Objection to Barratt Homes Application PL/2026/00195 – Land West of Westbury Road, Warminster

Executive Summary

Figure 1: Location of current Environment Agency fluvial flood zones relative to proposed development site

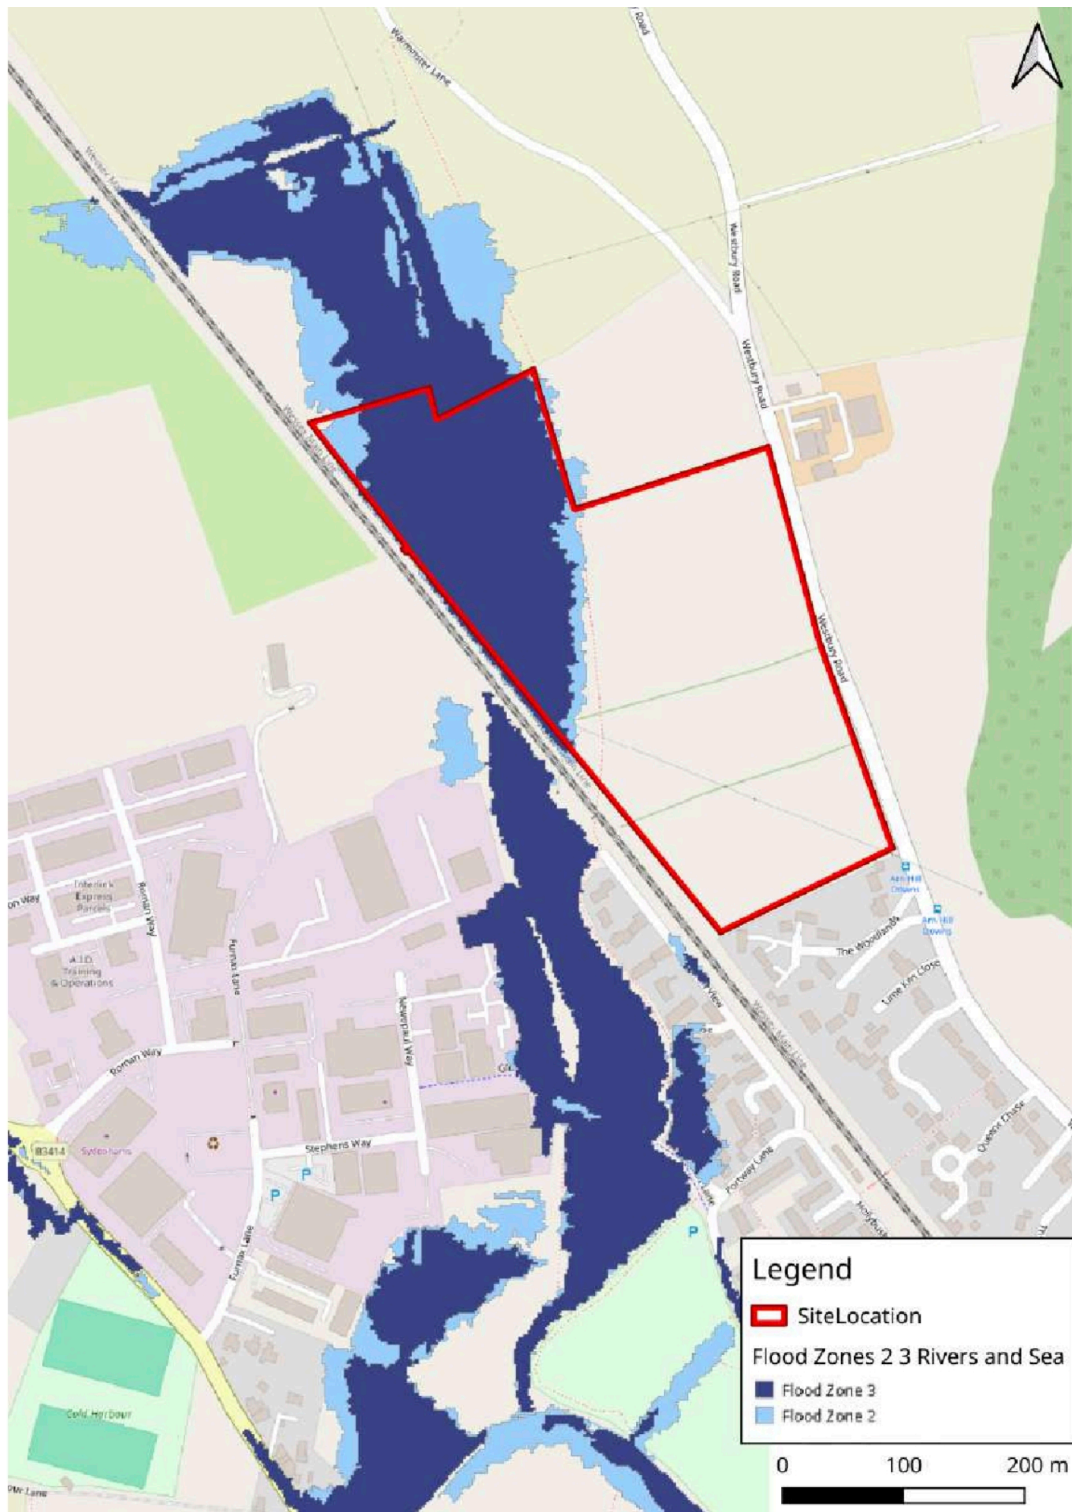
- The **Environment Agency Flood Map** remains the most credible source, corroborated by photographic evidence.
- Observed flooding often **exceeds Flood Zone 2 boundaries**, threatening proposed housing even within Flood Zone 1.
- Future flood risk is likely to worsen due to **climate change**, invalidating claims that the development would be safe "for its lifetime."

The Environment Agency Flood Map is the current accepted method by which flooding is assessed within the area of proposed development site.

Figure 13: Location of the three hydrological estimation points

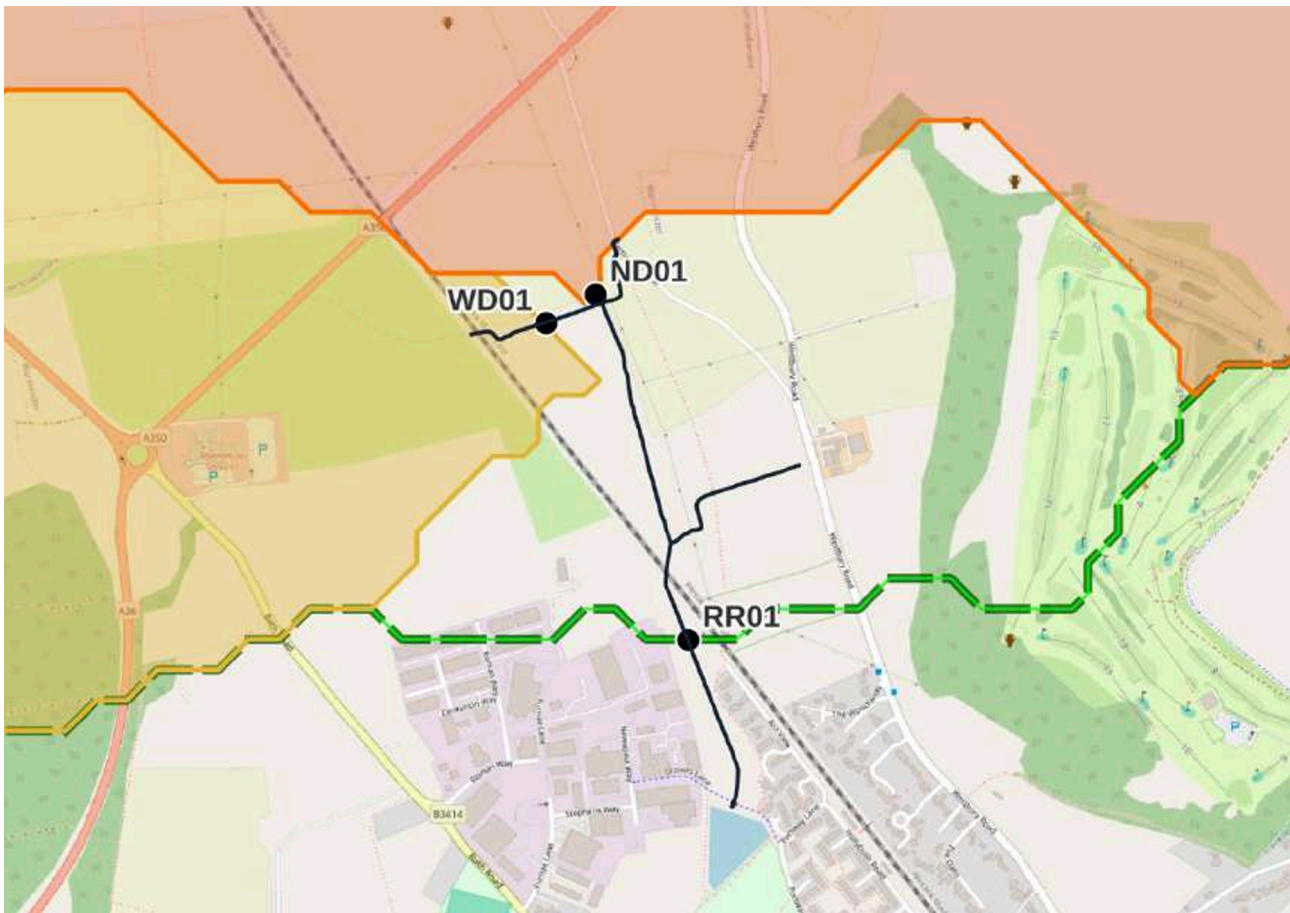
- In subsection 3.1 **Catchment Delineation**, the authors indicate that they used data from the **Flood Estimation Handbook (FEH)**.
 - There are significant limitations to the use of The Flood Estimation Handbook data.

- It was published in 1999, with its latest dataset taken in 2005/2006 so it twenty years out of date.
 - The FEH data is known to be generalised, not specific to certain areas.

- The last data set from 2005/2006 is therefore **20 years out of date and inaccurate**.
 - The FEH data creates high levels of uncertainty with **poor reliability for small catchment areas**.

- The proposed development site **is a small catchment so is prone to high levels of uncertainty**.
 - The authors used incorrect hydrological data estimation positions for their paper. Only one hydrological estimation point was relevant, point ND01, shown on map figure 13 on the next page. This is the only point at which the un-named stream runs (referred to in their paper as Portway stream).

- The above limitations and inaccuracies render all subsequent data, tables, results, calculations and conclusions inaccurate. They rely on 20 year outdated estimations (not direct measurement) using the inaccurate modelling of the **Revitalised Rainfall Runoff model version 2 (ReFH2)**, with its inherent unreliability.
- When the methodology of any paper or publication is unsound or faulty, the results and conclusions will be unreliable.
- This paper is therefore unreliable leaving the Environment Agency Flood maps as the most reliable source of information to assess flood risk for the proposed development site.

Quarterly Rainfall Pattern for Warminster showing changes from 2021 - 2026

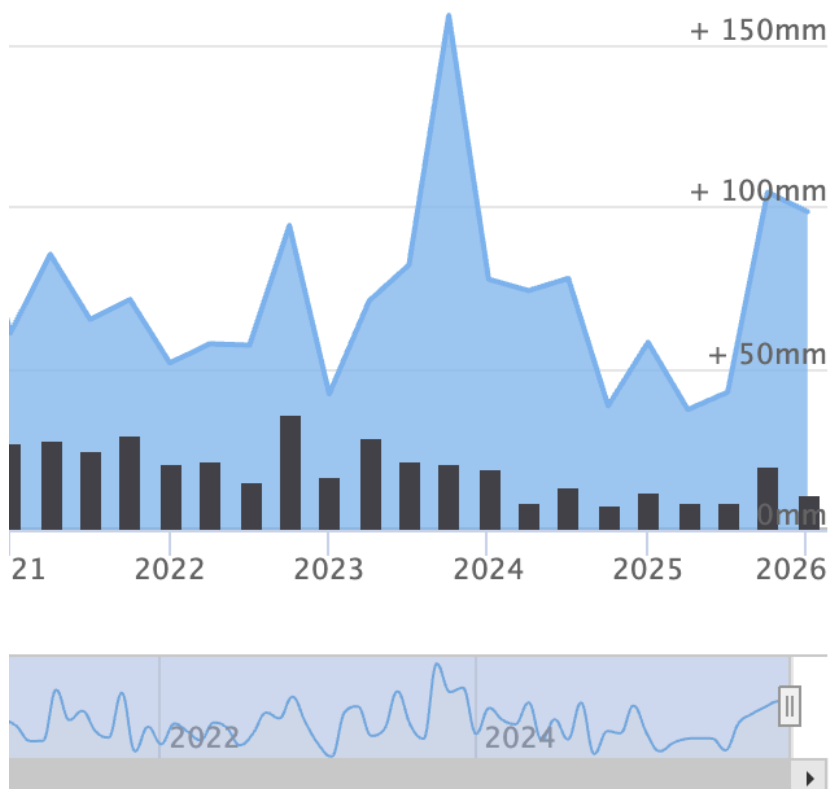
- Peak to trough differences between high and low average quarterly rainfall are more extreme and can be seen clearly in the Yearly Rainfall and Rain Day Averages graph on the next page.

The graphs demonstrates the peak to trough rainfall pattern has become more extreme.

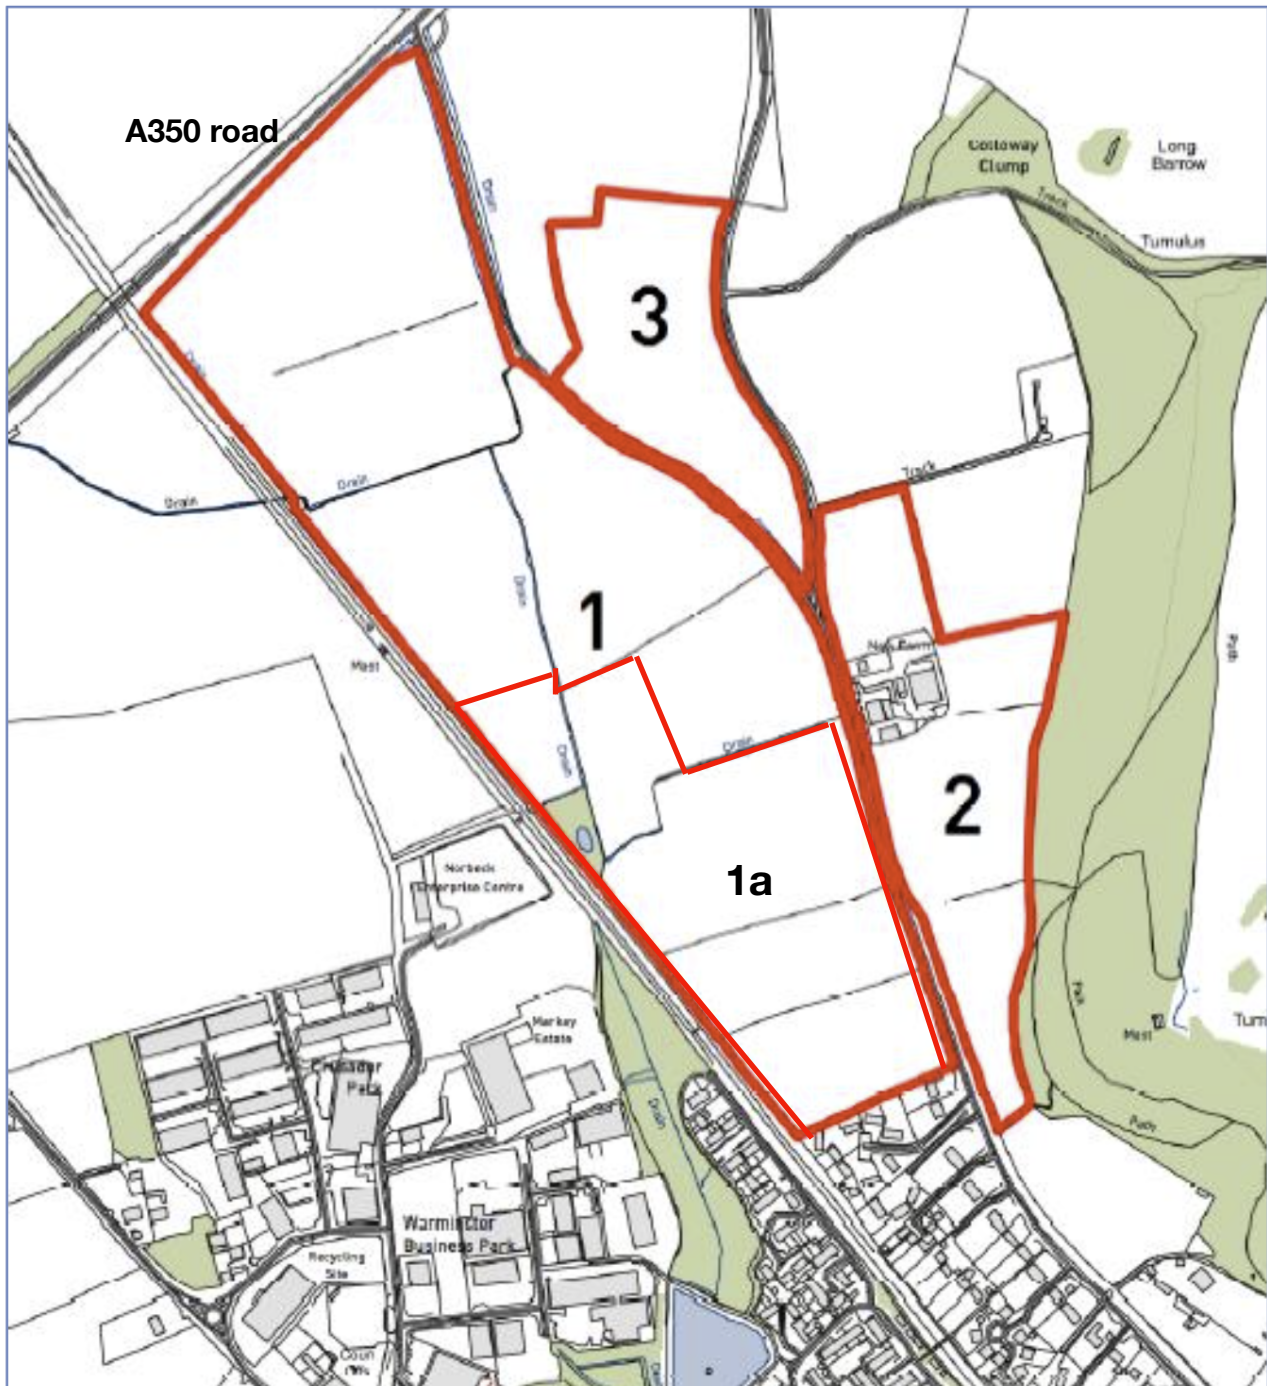
The two photographs below are drone aerial pictures of the proposed development site taken on 27 January 2026, by Andy Walczak of 6 The Woodlands. They differ from the Environment Agency Flood Map because observed flooding exceeds flood zone 2 boundaries.

Photograph 1. Shows that extensive flooding well exceeding the EA flood Map Flood zone 2 boundary encroaching into Flood zone 1, the area for the proposed development for “up to 205 houses”.

Photograph 2 below shows an extended view demonstrating that flooding across the area is extensive, well beyond the proposed development area towards the A350, running across land purchased by Barratt for future development shown by plots 1,2 and 3 shown on the map on the following page.

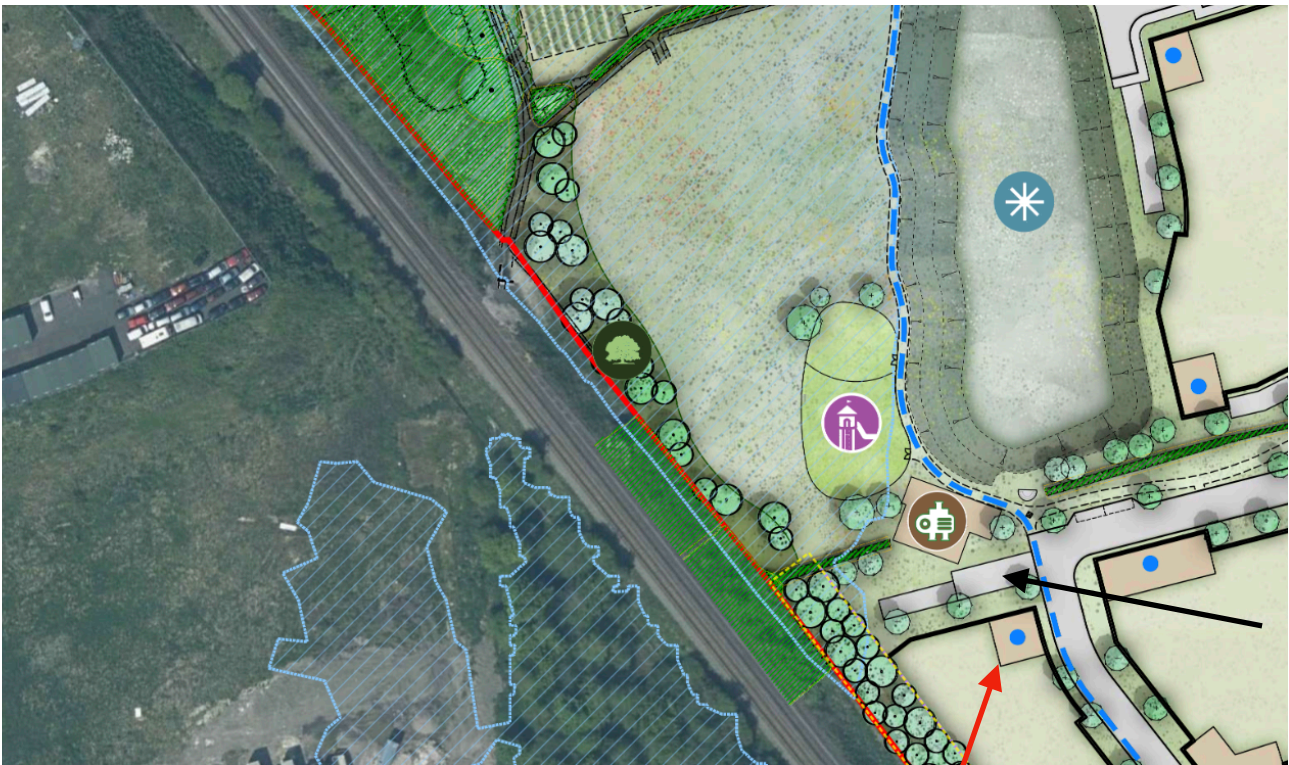
Below: is an expanded section of the Indicative Masterplan showing the position of the nearest house. Its garden would extend towards the treeline towards the embankment shown to the left of the house. The black arrow shows the position of the proposed access road. It is very short.

- The pumping station needs to be positioned at the lowest point in order for the Storage tank to collect free draining waste water from up to 205 houses built up hill from the unit.

- The regulations state that such a storage and pumping unit should be positioned at least 15 - 20 meters from the nearest house.
- The position of the Pumping Station indicates it is not compliant with these regulations.

- The regulations also stipulate that the Pumping Station requires its own access road, enabling repair vehicles to enter any time within a 24 hour period, unimpeded by parked vehicles.

- The plan shows a very short spur, not an access road. There is no provision for an access road for sole use of Sewerage Company vehicles, free from the impediment of parked cars so the proposed development does not comply with regulations.

- The short spur indicated on the plan does not comply with these regulations as they would be blocked easily by parked cars and the very short spur of a road could take more than one sewerage Company vehicle.

Figure 1: Location of current Environment Agency fluvial flood zones relative to proposed development site

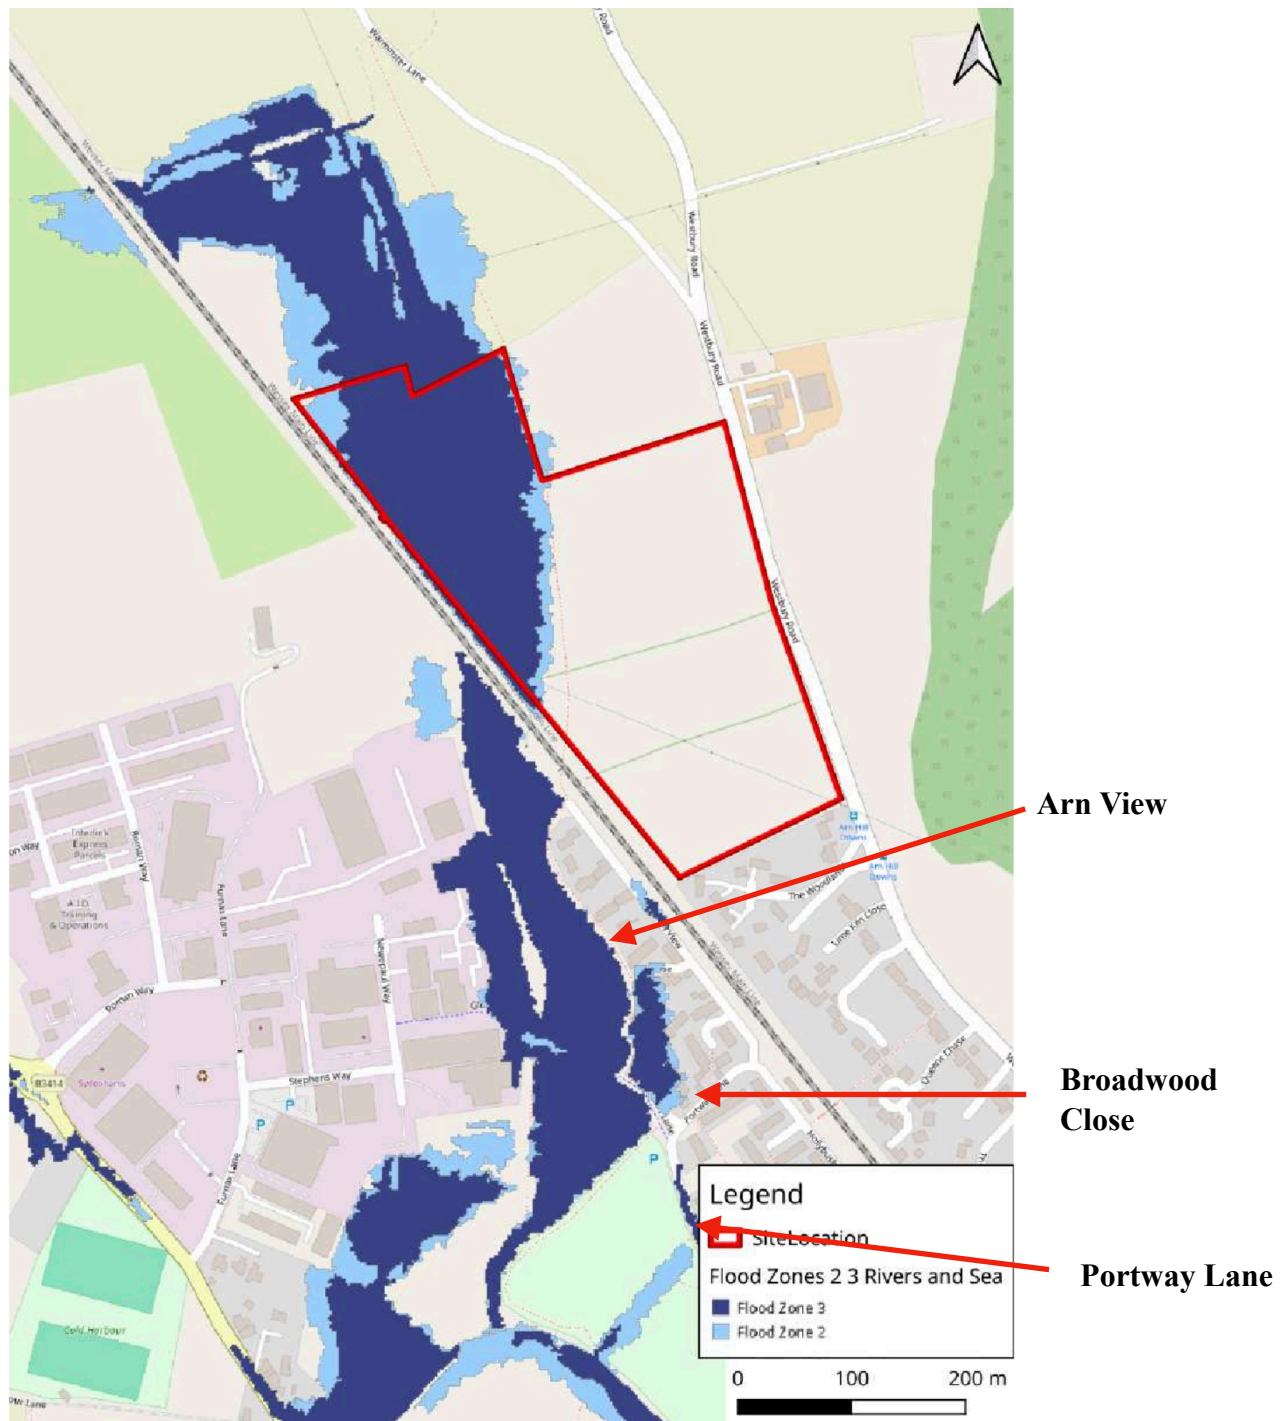
- The current flood risk to the proposed development site is significant meaning that additional runoff flowing through the culvert would put houses on Arn View, Broadwood Close, Portway Lane, and Hollybush Road at higher risk of flooding.

- The adverse effect on public health from flooding to the Woodlands STP are significant.
- The Environment Agency Map shows that Flood Zone 3 extends to housing estates to the west side of the railway embankment putting housing on Arn View and Broadwood Close and Portway Lane at greater risk from excess groundwater and flood water running through the culvert.

Below: The Environment Agency Flood Map showing the effects of flooding to the areas to the east of the culvert under the railway embankment.

Appendix E: Surface Water Flooding 1:30, 1:100, & 1:1,000

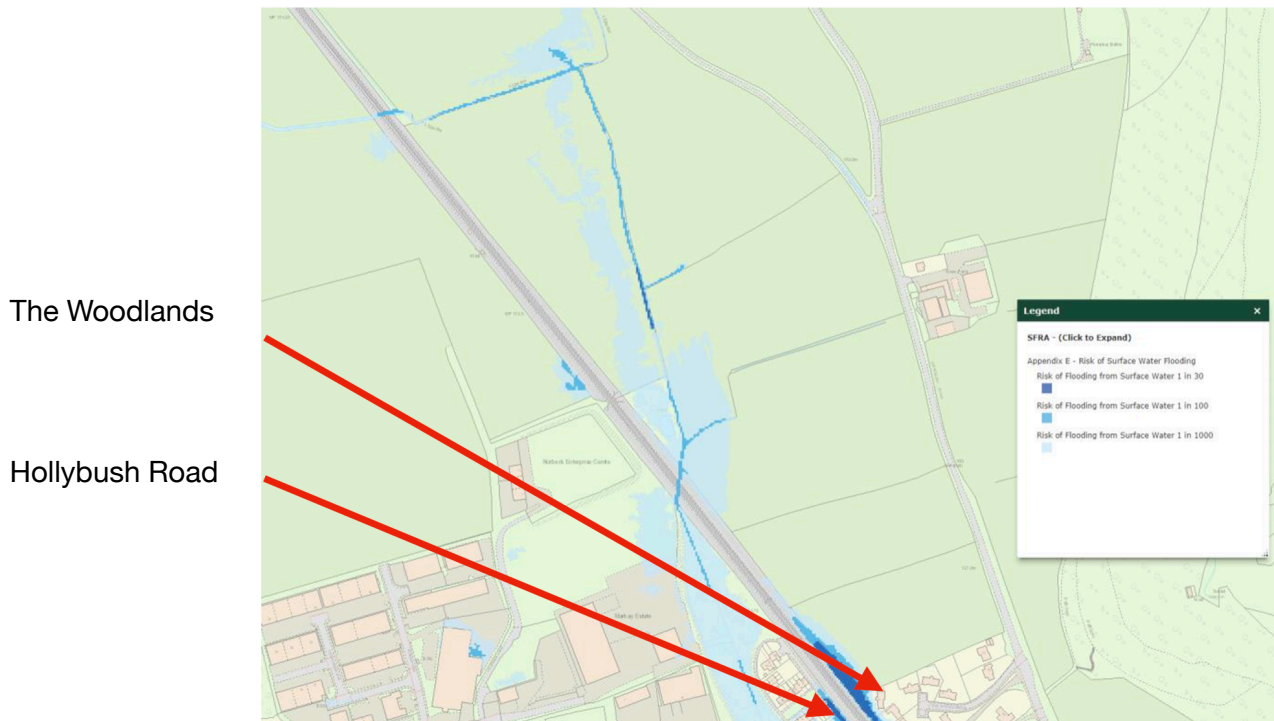
The Flood Map below shows surface water flooding to the west side of the culvert affecting Hollybush Road with that on the east side affecting The Woodlands, lying adjacent to the proposed development site. Surface water run off would compound this problem.
